Title SCH, RC-96 Tone Panel		
Size B	Number RC-96-TONEPNL	Revision B
Date: 9/26/2026	Sheet 1 of 1	
File: C:\Users\J\OneDrive\Documents\RC96_Tone.SchDoc	Drawn By: JHaas, KE0FF

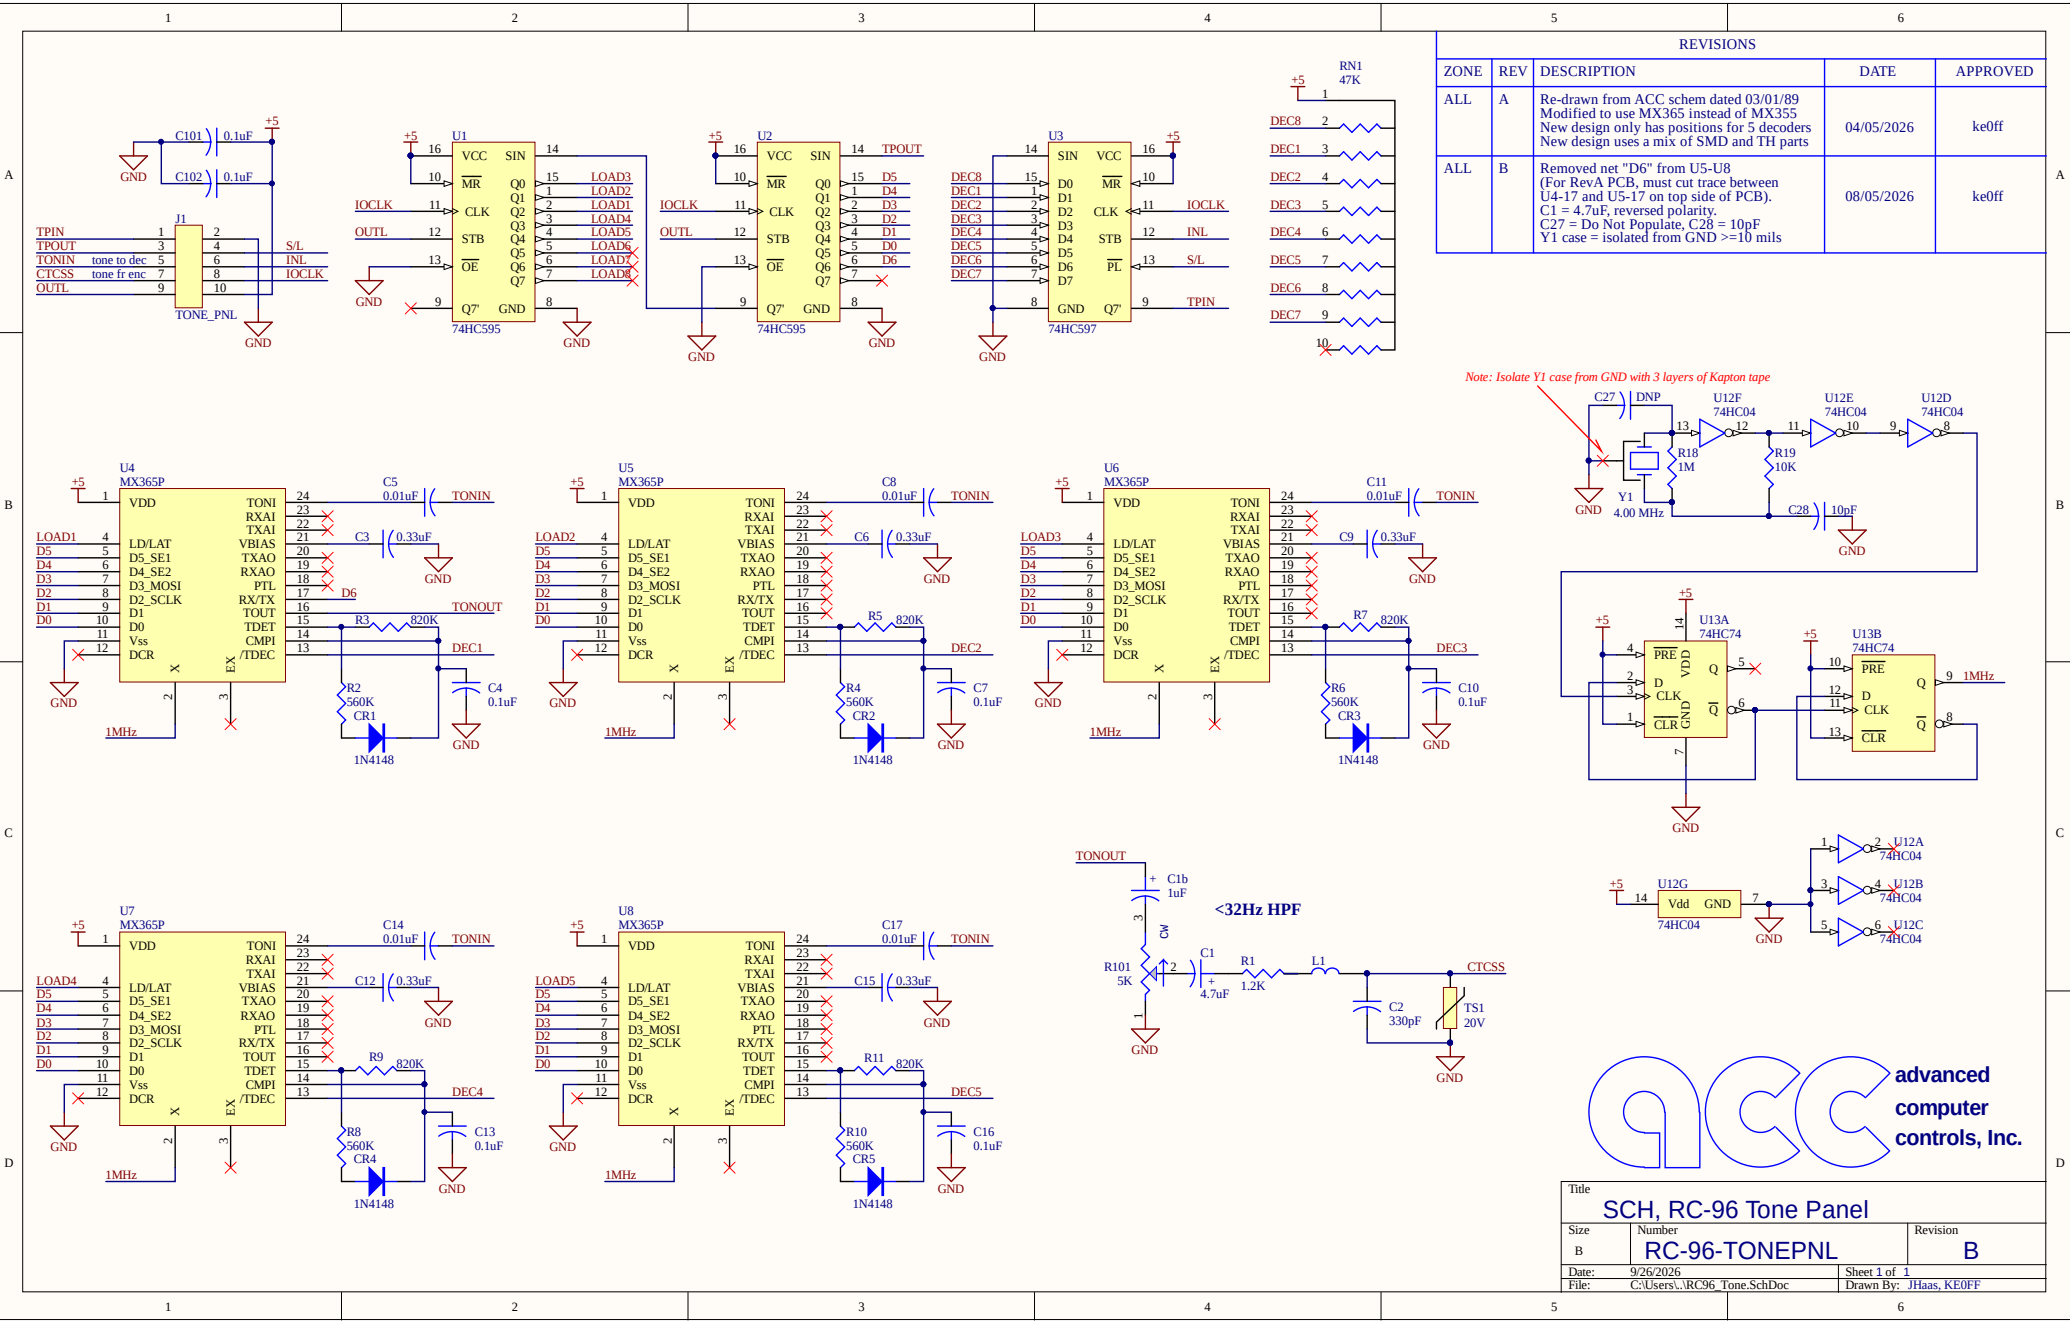
REVISIONS				
ZONE	REV	DESCRIPTION	DATE	APPROVED
ALL	A	Re-drawn from ACC schem dated 03/01/89 Modified to use MX365 instead of MX355 New design only has positions for 5 decoders New design uses a mix of SMD and TH parts	04/05/2026	keOff
ALL	B	Removed net "D6" from U5-U8 (For RevA PCB, must cut trace between U4-17 and U5-17 on top side of PCB). C1 = 4.7uF, reversed polarity. C27 = Do Not Populate, C28 = 10pF Y1 case = isolated from GND >=10 mils	08/05/2026	keOff

Note: Isolate Y1 case from GND with 3 layers of Kapton tape
